Re: Case No. 22-549-EL-BGN

Case No. 22-550-EL-BTX

Response to First Data Request from Staff of the Ohio Power Siting Board

**OAK RUN SOLAR PROJECT, LLC 'S
RESPONSE TO THE FIRST DATA REQUEST
FROM THE STAFF OF THE OHIO POWER SITING BOARD**

Monopole Structure Examples

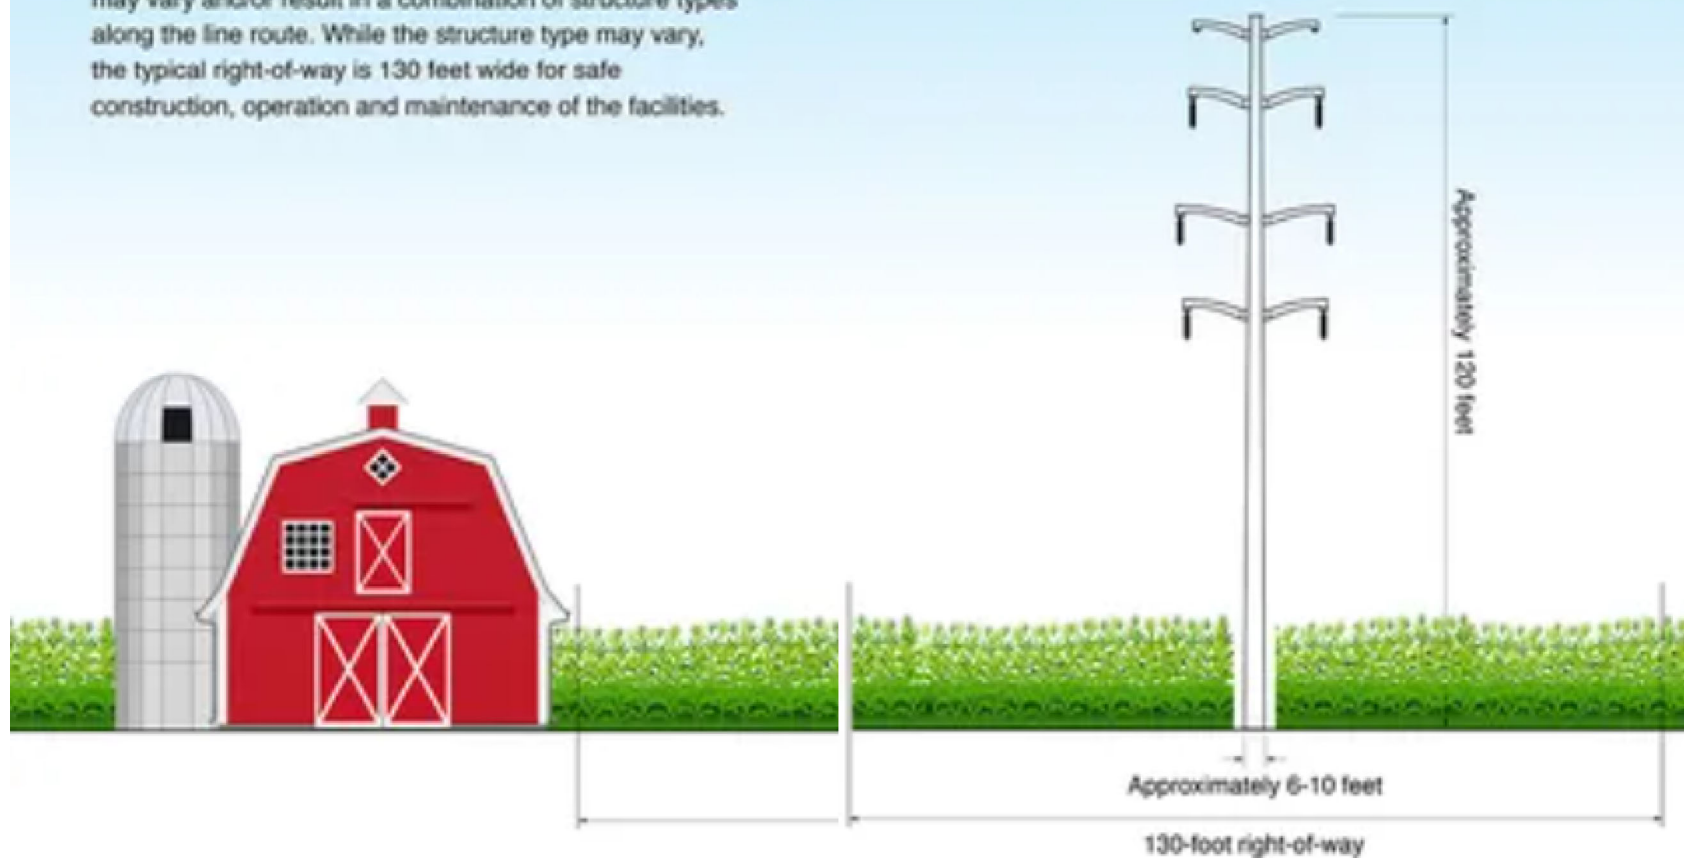
8. **The Application indicates the gen-tie lines will be supported on 26 steel monopoles at 120 feet tall and spaced 800 feet apart. Exhibit N indicates these poles will be supported on drilled cast in place concrete pier foundations. Please provide staff with specifics (i.e. depth, width, etc.) including a cross section diagram of these proposed foundations.**

Response: Design has not been completed for the transmission line structures, however, several typical design sheets and example images of similar 230 kilovolt (“kV”) monopole structures and 34.5 kV-230 kV substations are included as **Attachment 1** to this response.
